# The Tree Farm

CZ25-002

# Proposed Re-Zone & Development

# Comments & Responses - CO Division of Water Resources

# Comments & Responses - Colorado Geologic Survey

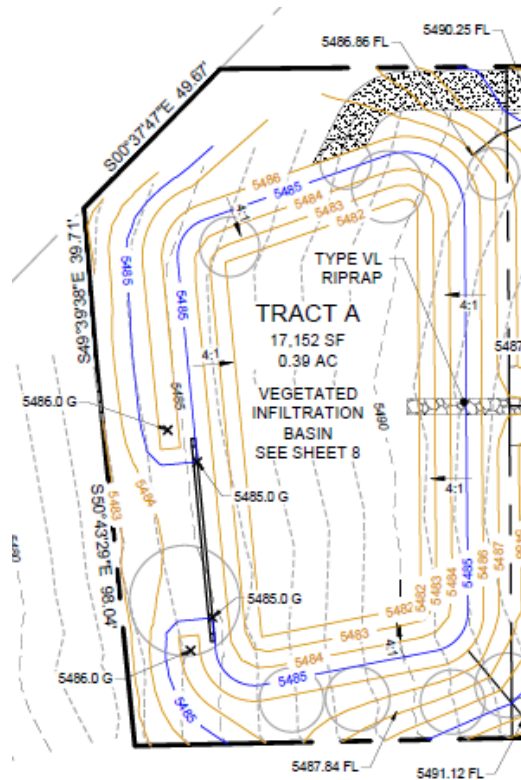
## ▶ Colorado Geologic Survey (CGS) Comments

- ▶ Soils Concern - Additional Drilling and Sampling Requested
- ▶ Attachment to Existing Storm Sewer
- ▶ Infiltration Basin Proximity

## ▶ Complete Engineering Services (CES) Responses

- ▶ Complete Engineering Services, Latsis' Soils Engineer, provided three (3) responses to CGS Comments.
- ▶ Complete Engineering Services conducted the following soils tests on the property:

- ▶ Soils testing on each proposed lot
  - ▶ Percolation testing of proposed infiltration basin area
  - ▶ Swell consolidation testing in 4 locations per CGS request.

- ▶ Testing and Responses conclude:
  - ▶ "Soils are well suited for an infiltration basin"
  - ▶ Storm sewer connections are not available to this property and a TRC request was approved.

- ▶ "The confining layer is greater than 20' below the existing ground surface."
  - ▶ "Additional investigation conducted by CES indicates soils present do not exhibit extreme hydrocompaction tendencies."

- ▶ "There is no groundwater present above a depth of 30 feet".
  - ▶ "Presence of the infiltration basin will have no negative effects on existing or proposed structures in the vicinity of the basin"

- ▶ "Groundwater mounding will be minimal and will not affect surrounding properties."
